From: Comar, Manny
Sent: Thursday, November 01, 2012 5:02 PM
To: TurkeyCOL Resource
Subject: FW: DRAFT RAI Responses FPL Turkey Point 6 & 7 for eRAI 6024 Basic Geologic and Seismic Information
Attachments: Draft Revised Response for NRC RAI Letter No. 041, RAI 02.05.01-32 (eRAI 6024).pdf; Draft Revised Response for NRC RAI Letter No. 041, RAI 02.05.01-11 (eRAI 6024).pdf; Draft Revised Response for NRC RAI Letter No. 041, RAI 02.05.01-13 (eRAI 6024).pdf

NRC RAI Letter No. PTN-RAI-LTR-041

SRP Section: 02.05.01 - Basic Geologic and Seismic Information

NRC RAI Number: 02.05.01-32 (eRAI 6024)

Figure 1. Fault Map of Cuba

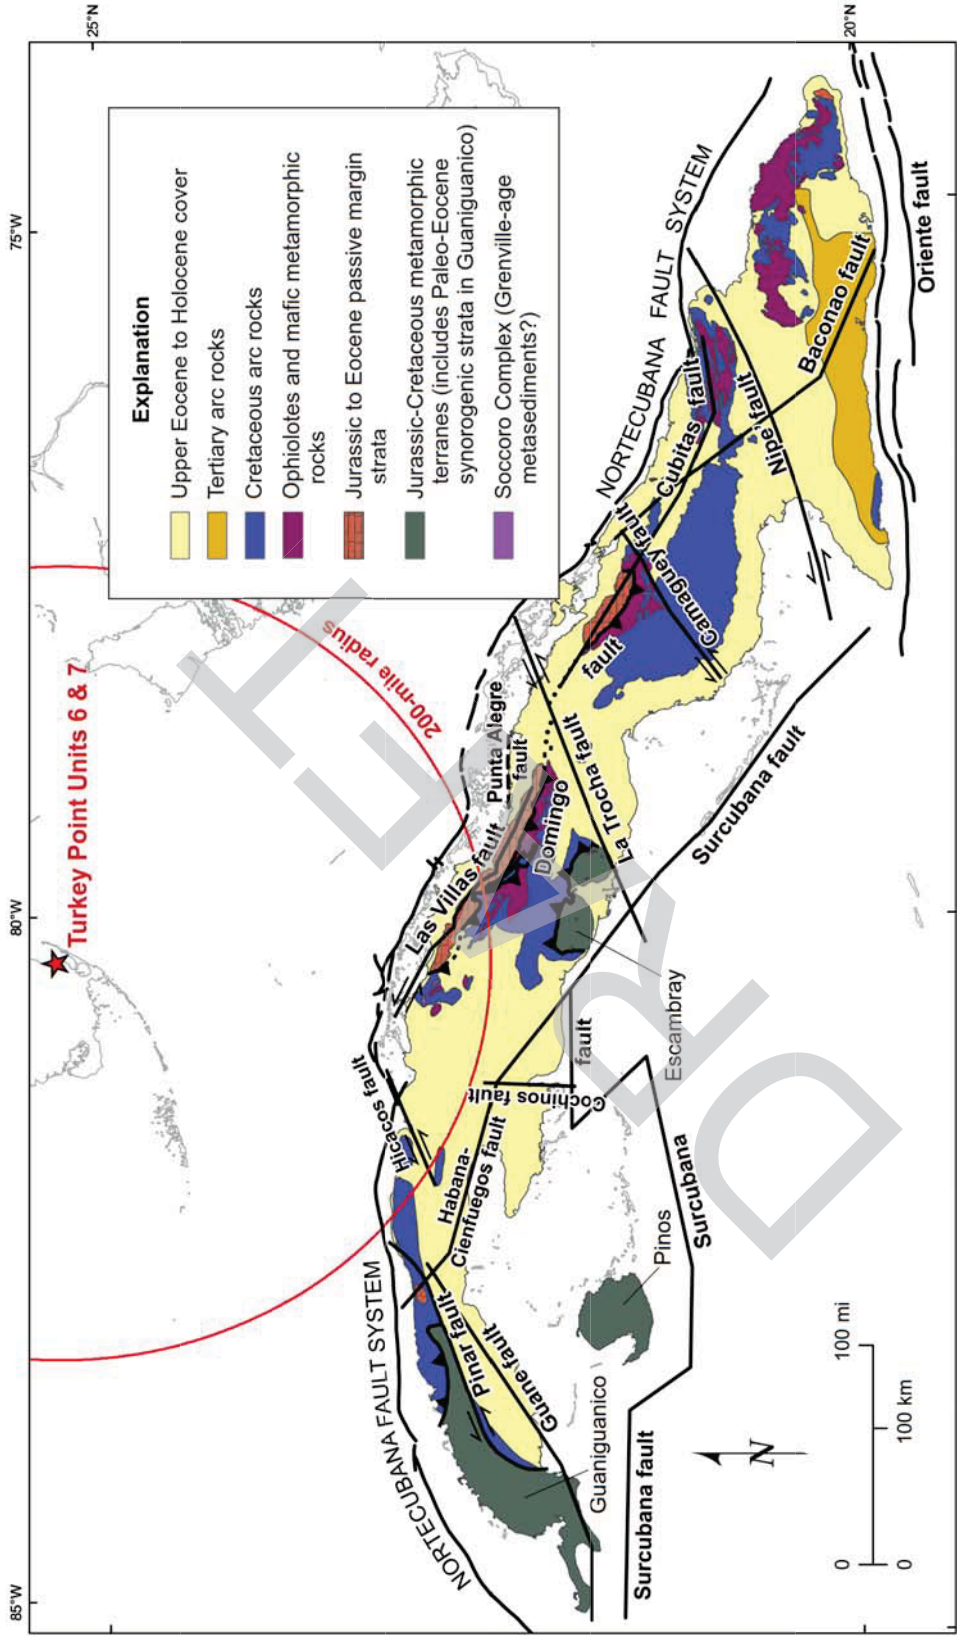
FSAR Section 2.5.1.1.1.3.2.4 states: "In an effort to explain seismicity that continues on intraplate Cuba, 12 faults on the island of Cuba have been designated as 'active' (Reference 494), but that published analysis does not provide sufficient information to conclude that a structure is capable". The staff notes that this statement does not corroborate conclusions made by published experts in the area (e.g. Cotilla-Rodríguez et al. 2007, Garcia et al. 2003) regarding active faults in Cuba. In order for the staff to assess the tectonic and structural features within the site region and in accordance with 10 CFR 100.23, please address the following:

- a) Clarify the distinction between active and capable fault.
- b) If the 12 faults are not capable tectonic sources, please discuss what is the structure or source of the seismicity of northern Cuba in light of Cotilla-Rodríguez et al. 2007 and Garcia et al. 2003 alternative conclusions.

According to Cotilla-Rodriguez et al. (2007) (FSAR Reference 2.5.1-494), 12 faults in Cuba meet their definition of active. These 12 faults include the Bacanao, Oriente, Cochinos, Camaguey, Cauto-Nipe, Cubitas, Guane, Habana-Cienfuegos, Hicacos, La Trocha, Las Villas, and Nortecubana faults (Figure 1). Of these 12 faults, only seven are located in northern Cuba. These seven faults are the Cochinos, Guane, Habana-Cienfuegos, Hicacos, La Trocha, Las Villas, and Nortecubana faults.

Figure 2.5.1-229 Regional Tectonic Features

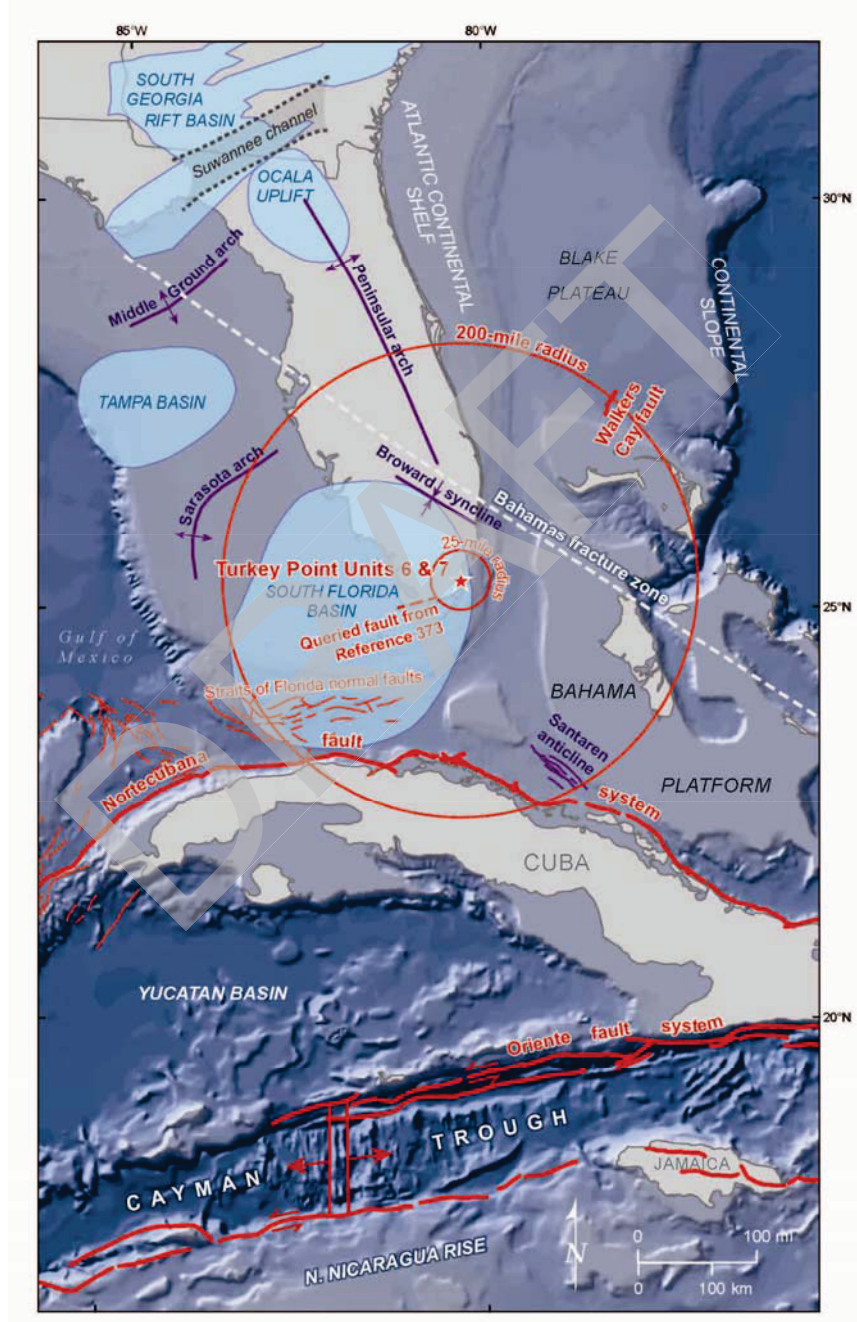
FSAR Section 2.5.1.1.1.3.2 “Principal Tectonic and Structural Features” states that the site region has generally recorded only sedimentary processes since Mesozoic rifting, with the exception of tectonic activity associated with the collision of the Greater Antilles Arc with the Bahamas Platform during Cretaceous to Eocene time. The staff notes that this suggests that there has been no tectonic activity in the site region since the end of the Eocene (~34 Ma). However, the north coast of Cuba, the Walkers Cay fault, the Santaren Anticline, and the Straits of Florida normal faults all occur within the site region and show evidence for post-Eocene tectonic activity.

In order for the staff to fully understand site region specific geology, and in support of 10 CFR 100.23, please address the following: Update this discussion to clarify the timing and location of all tectonic features in the site region and place into the regional tectonic setting.

As described in FSAR Subsection 2.5.1.1.1.3.2.2 and RAI Response 2.5.1-16, the Straits of Florida normal faults were primarily active in the Eocene and acted to thin the overthickened wedge of foreland material shed off the colliding Greater Antilles arc (FSAR References 2.5.1-221 and 2.5.1-482) (FSAR Figure 2.5.1-229). These structures were

FSAR Figure 2.5.1-229 will be revised in a future COLA revision to include a label for the Straits of Florida normal faults as shown below:
